CONSTRUCTION SUMMARY

Lindsay 2017 Developments Inc. / Sugarwood

Lot/Unit: 187 Block 96 Phase/Building: 1 Model/Floor Plan: Mitchell Lake(2002)Elev B 3Bed 2.5Bath

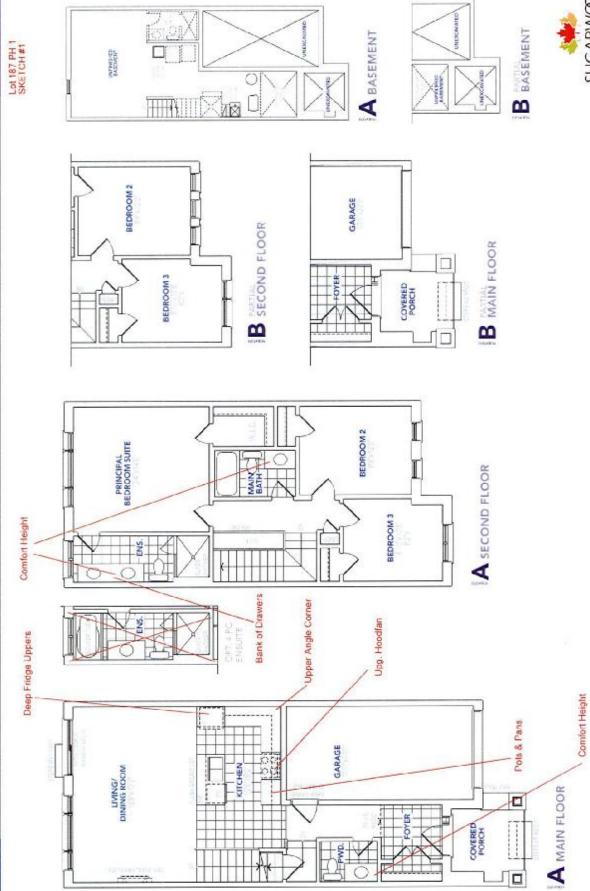
Inv. 6605	1 - TO SUPPLY AND INSTALL AN ADDITIONAL BASIC RECEPTACLE (NOT		
	DEDICATED) AT 66" UP FROM THE GROUND OVER THE F/P MANTLE. SEE SKETCH		
	#2		
Line 82428	Note:		
9Jun25 / 19Jun25			
Inv. 6605	1 - TO SUPPLY AND INSTALL STD TV AND PHONE ROUGH-IN, SEE SKETCH #2 FOR		
	LOCATION		
Line 82421	Note:		
9Jun25 / 19Jun25			
Inv. 6605	1 - To relocate the standard kitchen light to over the island, see sketch #2		
Line 82422	Note:		
9Jun25 / 19Jun25			
Inv. 6605	2 - DO NOT INSTALL THE STANDARD MAIN HALLWAY LIGHT & KEEP THE		
	SWITCH SUPPLY & INSTALL TWO IC 4 in POT LIGHT C/W PAR 20 BULB AND		
	WHTIE TRIM CONNECTED TO THE STANDARD SWITCH SEE SKETCH #2		
Line 82423	Note:		
9Jun25 / 19Jun25			
Inv. 6605	4 - TO SUPPLY & INSTALL FOUR IC 4 in POT LIGHT C/W PAR 20 BULB AND WHTIE		
	TRIM CONNECTED TO A SEP SWITCH IN THE KITCHEN, SEE SKETCH #2		
Line 82424	Note:		
9Jun25 / 19Jun25			
Inv. 6605	4 - TO SUPPLY & INSTALL FOUR IC 4 in POT LIGHT C/W PAR 20 BULB AND WHTIE

TRIM IN THE LIVING/DINING ROOM CONNECTED TO A SEP. SWITCH, SEE SKETCH		
	#2		
Line 82425	Note:		
9Jun25 / 19Jun25			
FIREPLAC	${f E}$		
Inv. 6605	1 - TO SUPPLY AND INSTALL OPT. ELEC. F/P		
Line 82426	Note:		
9Jun25 / 19Jun25			
9Jun25 / 19Jun25
